NORTH FALLS

Offshore Wind Farm

Draft Marine Mammal Mitigation Protocol (~~Clean~~Tracked)

Document Reference: 7.7
Volume: 7
Date: ~~July~~December 2025
Revision: ~~45~~

Plate 1.2 Proposed piling mitigation procedures.

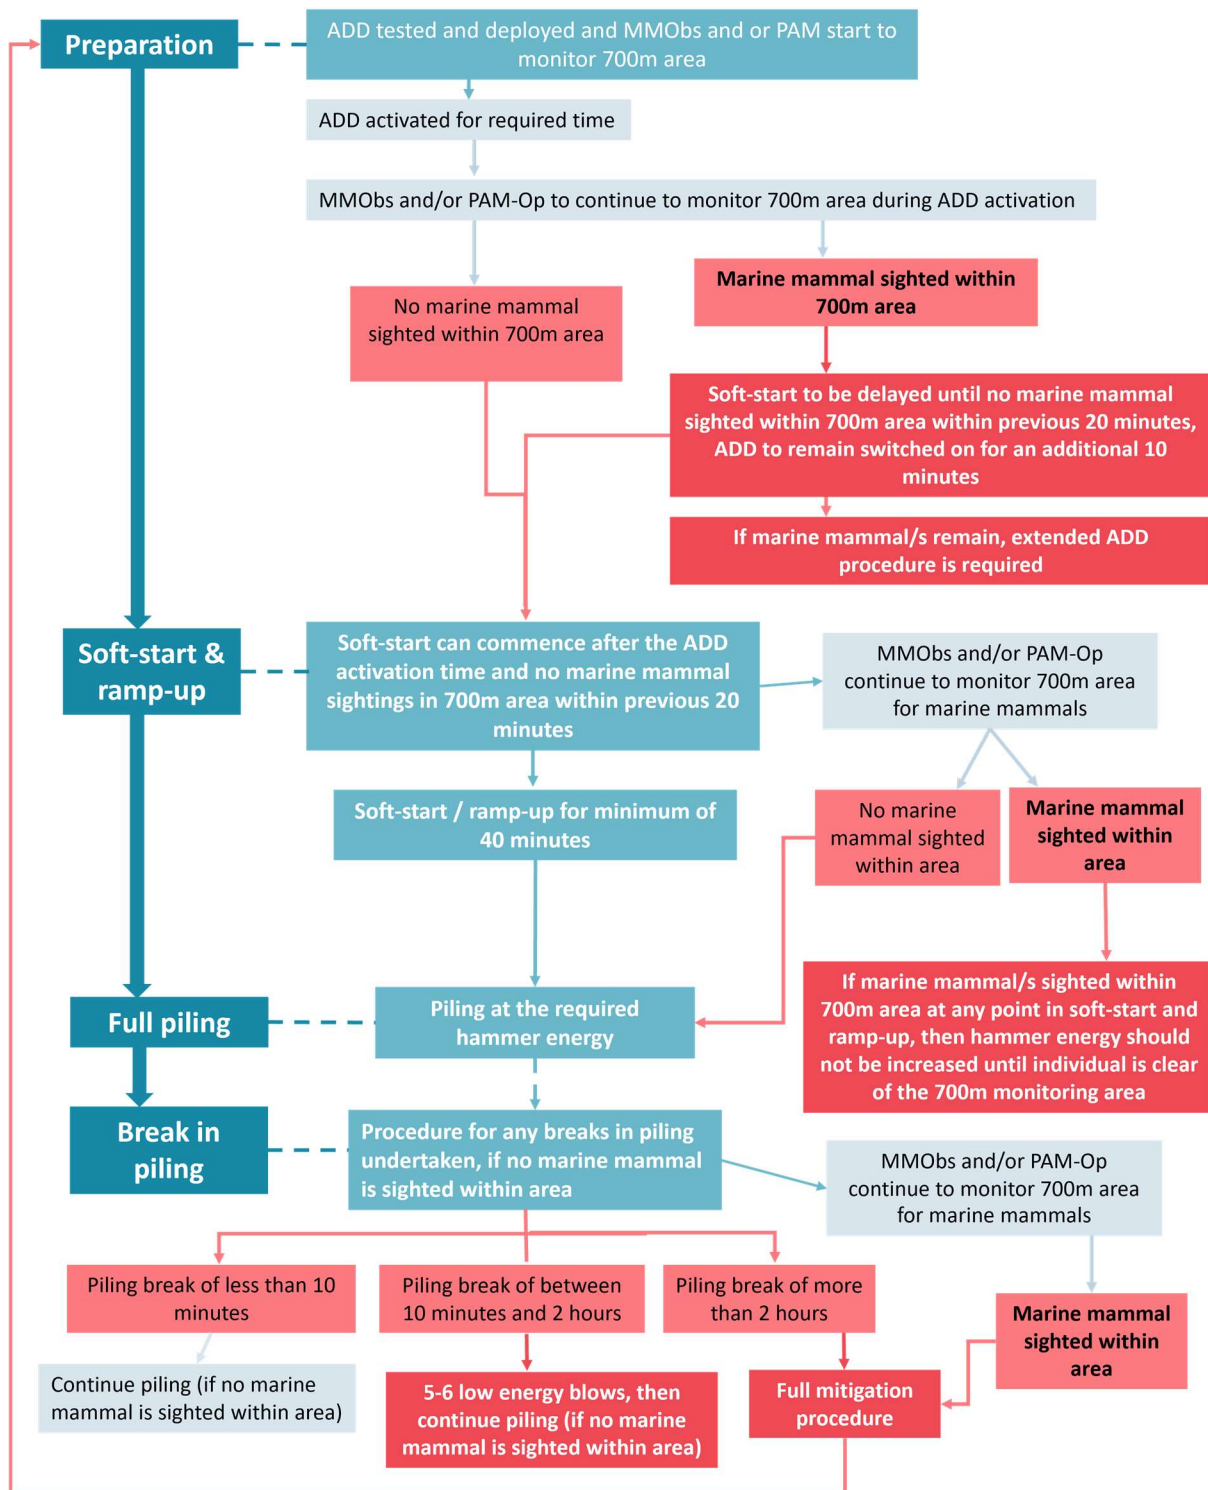
- ~~13. The Draft MMMP (Revision 3) includes updates to Plate 1.2 to ensure it matches the text regarding soft start and ramp up procedures, and to make clear that piling will only continue after a break if there are no marine mammals present.~~

Natural England REP7-088	Table 1 _1	We are content with the amendments of the Plate 1.2 as per our advice.	Noted, no further action required.
Natural England REP7-088	Table 1 _2	Natural England notes that the Applicant has not accepted our advice on the use of Passive Acoustic Monitoring (PAM) for Unexploded Ordnance (UXO) clearance. The Marine Mammal Mitigation Protocol (MMMP) [REP6-030] still refers to this as 'unlikely to be required'. We also note the Applicant's response in E27 of Table 1.5 Examination Comments and Relevant Representations: "For UXO clearance the Applicant has committed to the use of PAM in instances when there are not favourable conditions with good visibility (sea state 3 or less)." Our advice remains that PAM is a required monitoring tool for UXO clearance especially given that the proposed development is	The Draft MMMP [REP6-029 Document 7.7, Rev 5] contains details for how PAM will be utilised, as set out in Section 1.4.3.2.2. As per Natural England's request the text has been amended to ensure PAM, if required, will be used in conjunction with the MMObs for the UXO clearance mitigation procedures.

Appendix B. Plots for Comparable Hammer Strike Energies

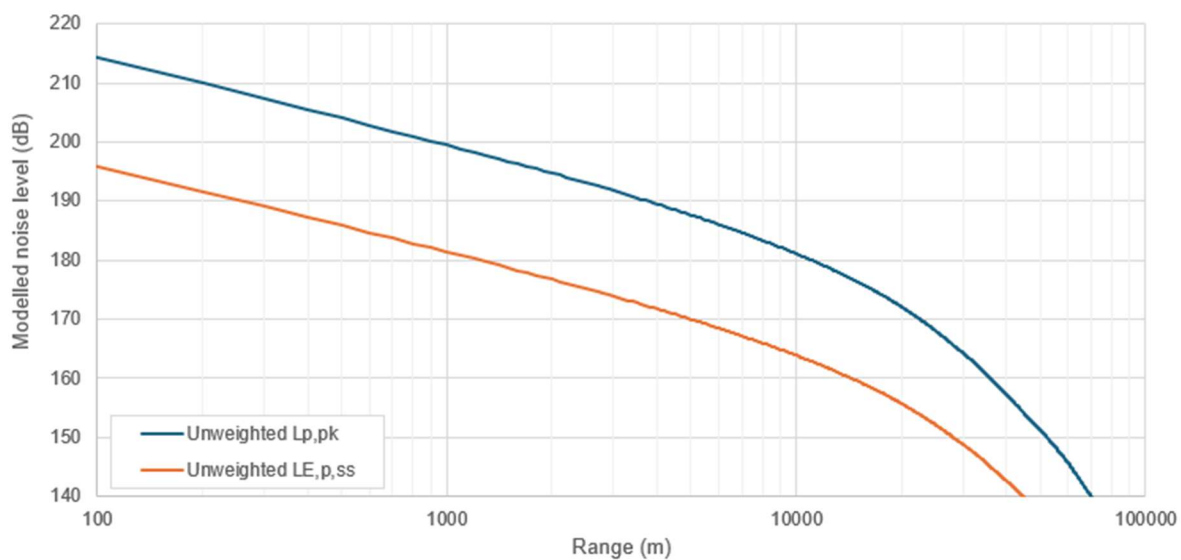
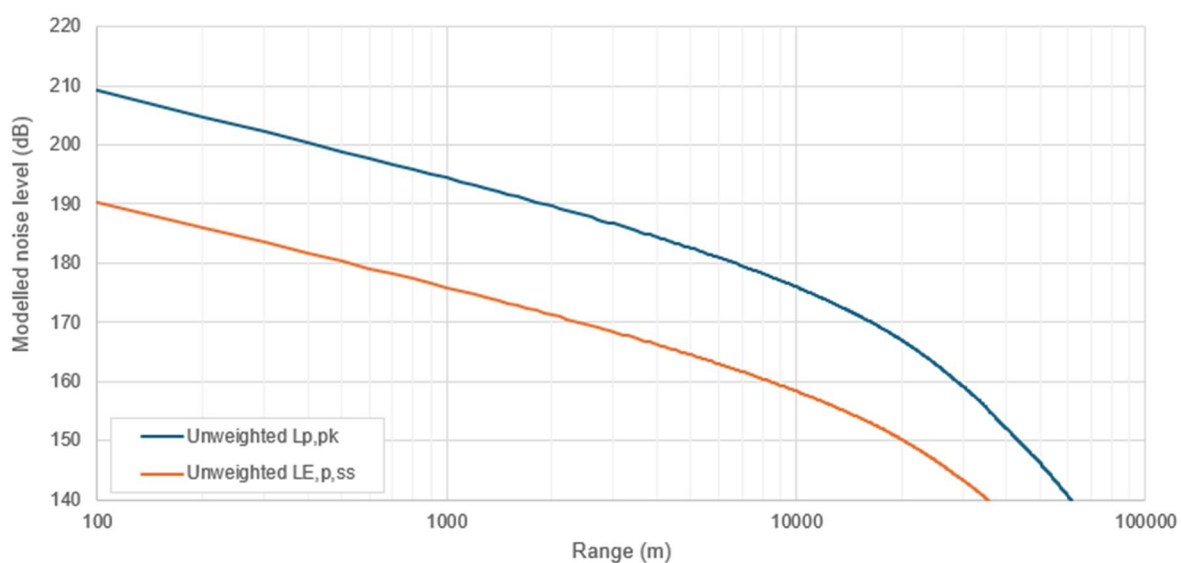
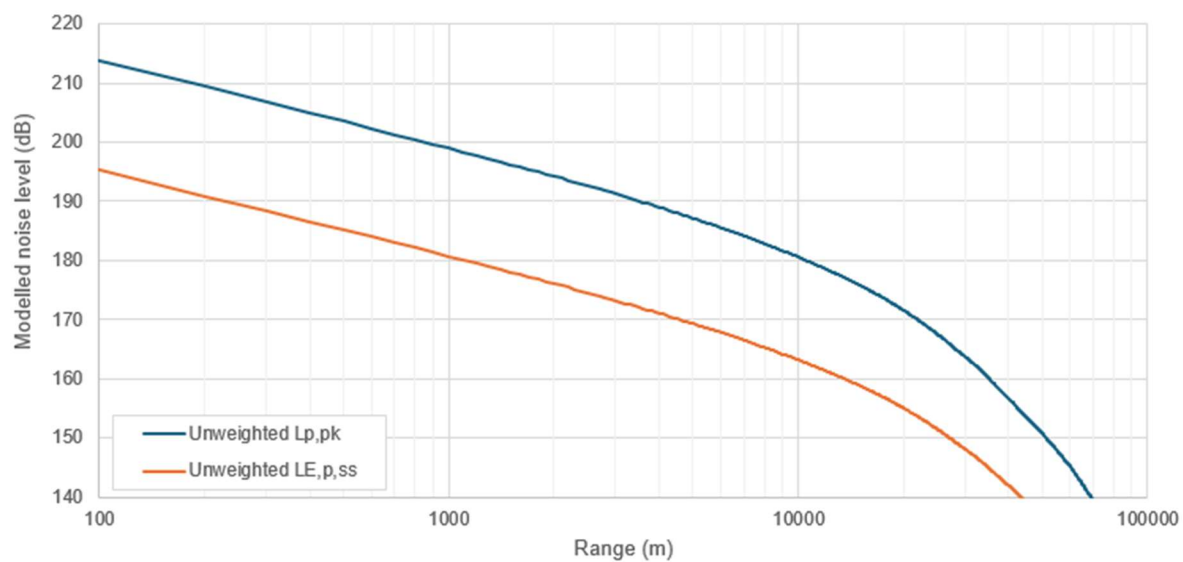
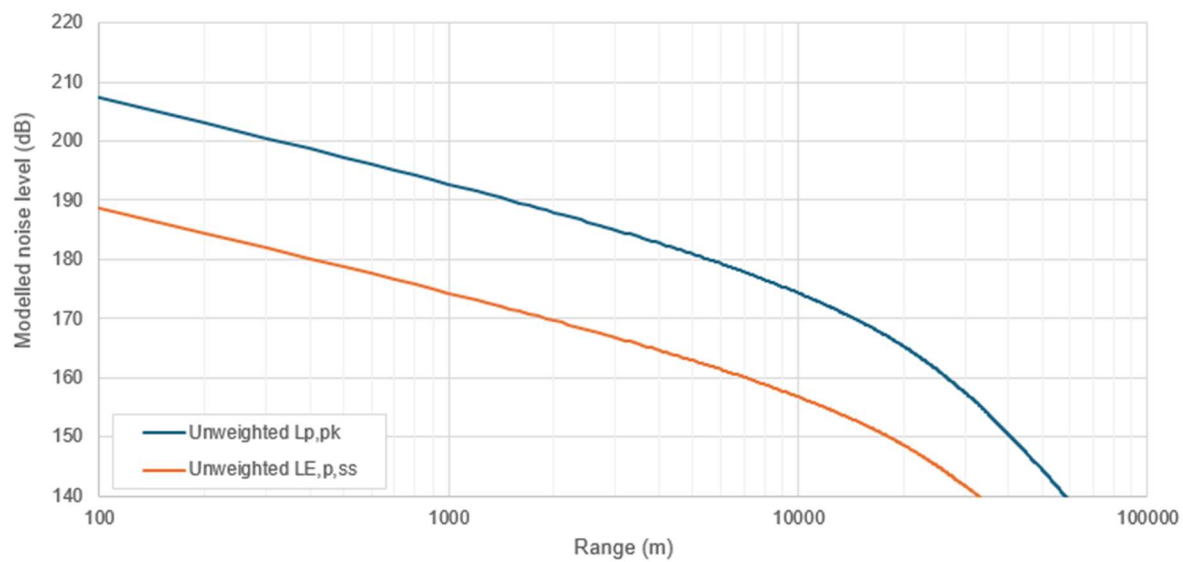
Consultee	Reference	Comment	Response / where addressed in the MMMP
		be required for a high-order clearance of a device of 120kg or higher.	
MMO	MMO-186	It is the understanding of the MMO that bubble curtains will be required for all high-order detonations, and this should be clear in the final MMMP. The MMO suggests that the Applicant consults with the specific UXO contractor to determine the appropriate parameters for safely deploying bubble curtains. If environmental conditions are not conducive to the use of a bubble curtain, then the MMO recommends postponing any high-order detonations until conditions are suitable.	As above in response to MMO-184.
MMO	MMO-195	The purpose of the noise monitoring during construction is to determine the actual underwater noise levels on site for comparison with the modelled levels presented in the ES. The MMO acknowledges that the measurements taken during installation will be constrained by various factors such as the piling plan and site limitations and a direct (like-for-like) comparison with a modelled scenario is unlikely to be possible. Nevertheless, even if the piling locations and choice of transects would not be matched precisely, both modelling and monitoring should provide enough information to deduce some envelope of received level curves in each case. Thus, some sort of comparison/s in the form of 'level vs range' plots (for comparable hammer strike energies), with the associated envelopes of variability, should be possible and would be expected. Therefore, the MMO recommends that such a plot is provided.	The Applicant has noted this comment from the MMO, therefore, these plots have been provided in Appendix B as part of the revised Draft MMMP (Revision 1).
